November 21, 2008

**Public Comment and Response on the  
Draft Master Plan for the Laurel Hill Adaptive Reuse Area**

The comments and responses are arranged topically. Responses were prepared by the Department of Planning and Zoning and The Alexander Company.

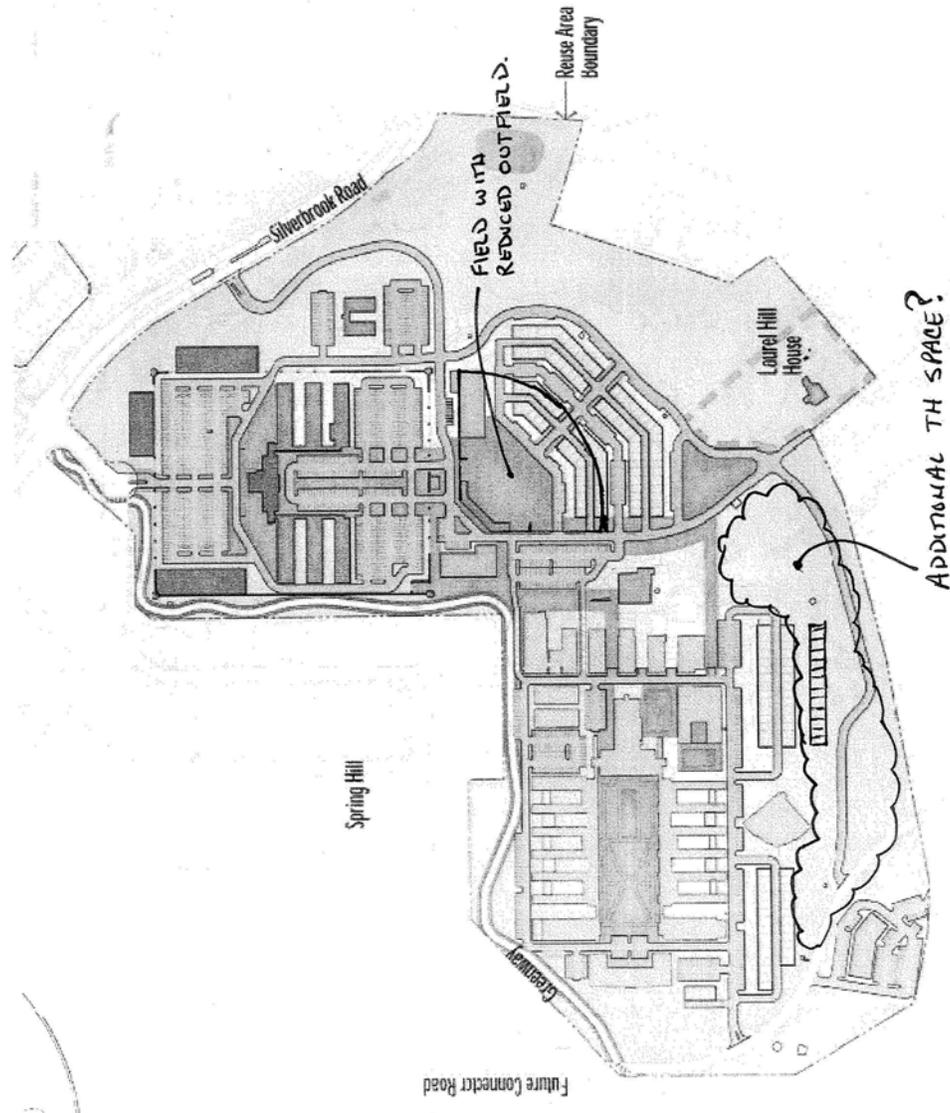
The following suggestion was made at a previous meeting to the Alexander Company and Fairfax County as a plan to keep the historic ball field and allow development at the same time.

The revitalization of this historic field has the potential to return more revenue to the people that have businesses in the area and the future businesses being built, by providing more exposure to the area with such a “diamond in the rough”.

What can be done?

1 – Decrease the outfield size to a traditional sized outfield. This would still allow 55 out of the 90 currently designed townhouses to be built. We recommended an outfield retail loop similar to Camden yards. The business would experience additional revenue with the ball field intact.

**H. Tony Martin (see following page)**

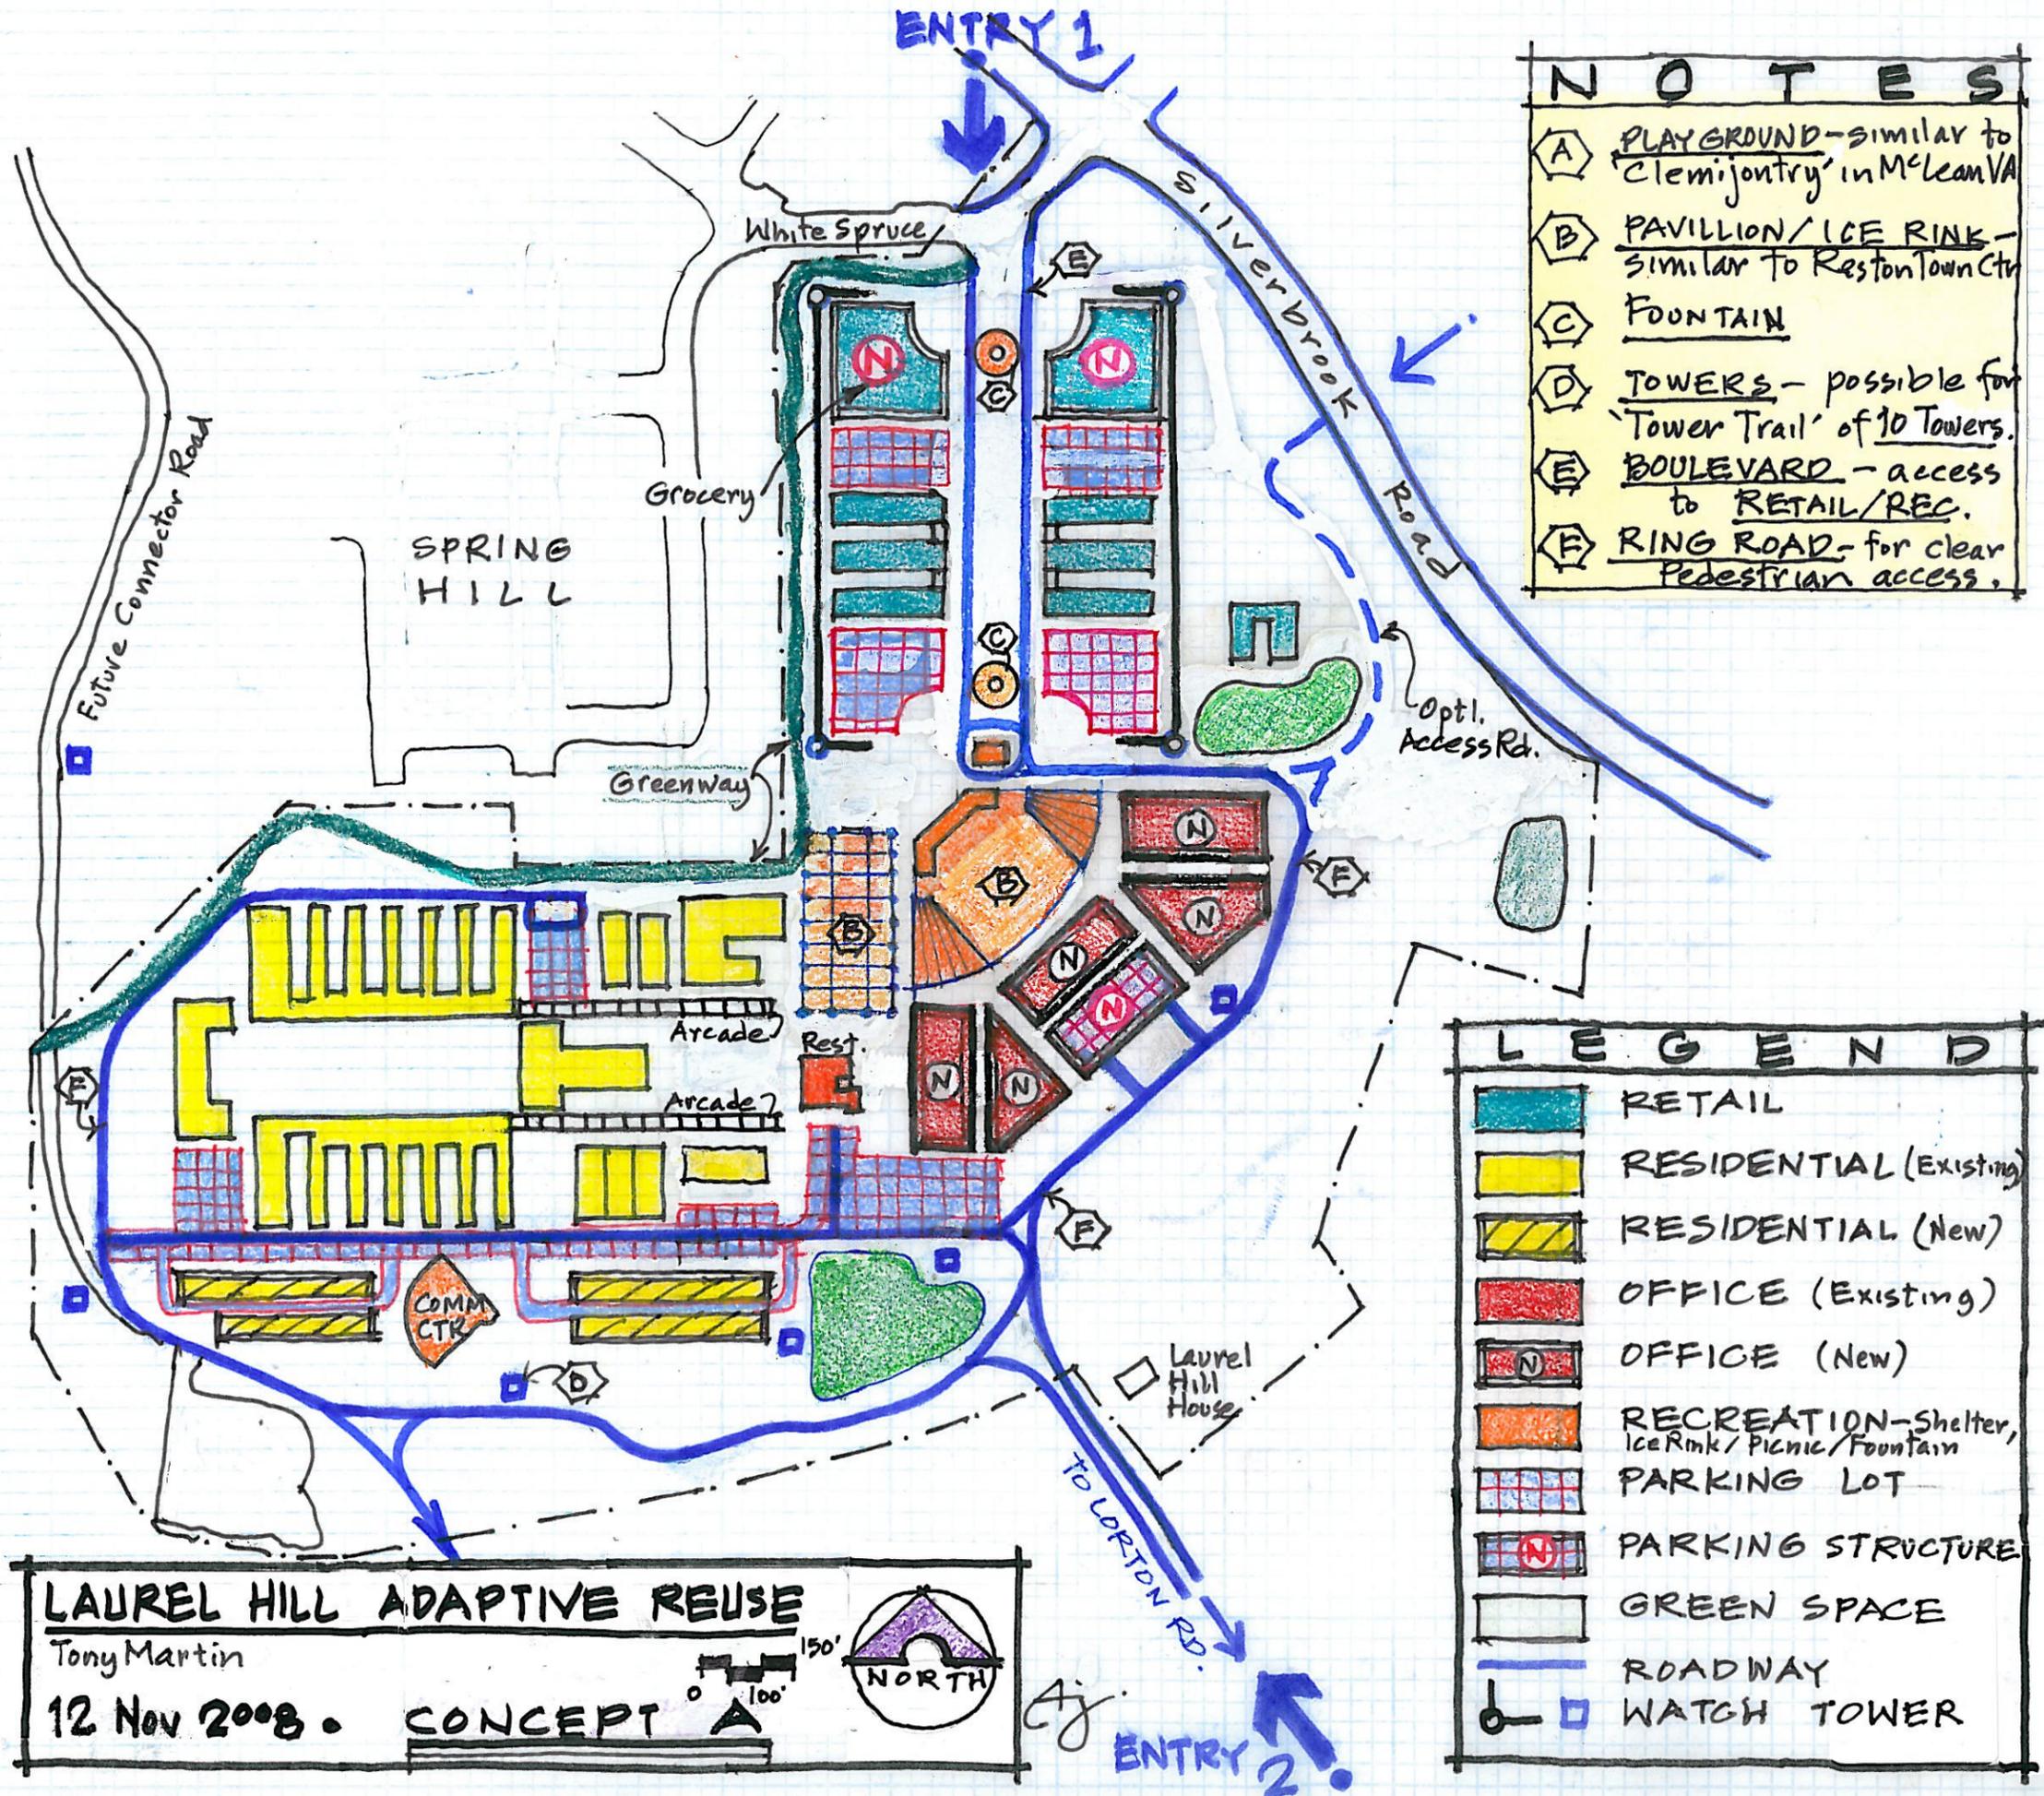
- ### NOTES
- (A) PLAYGROUND - similar to 'Clemijontry' in McLean VA
  - (B) PAVILLION / ICE RINK - similar to Reston Town Ctr
  - (C) FOUNTAIN
  - (D) TOWERS - possible for 'Tower Trail' of 10 Towers.
  - (E) BOULEVARD - access to RETAIL / REC.
  - (F) RING ROAD - for clear pedestrian access.
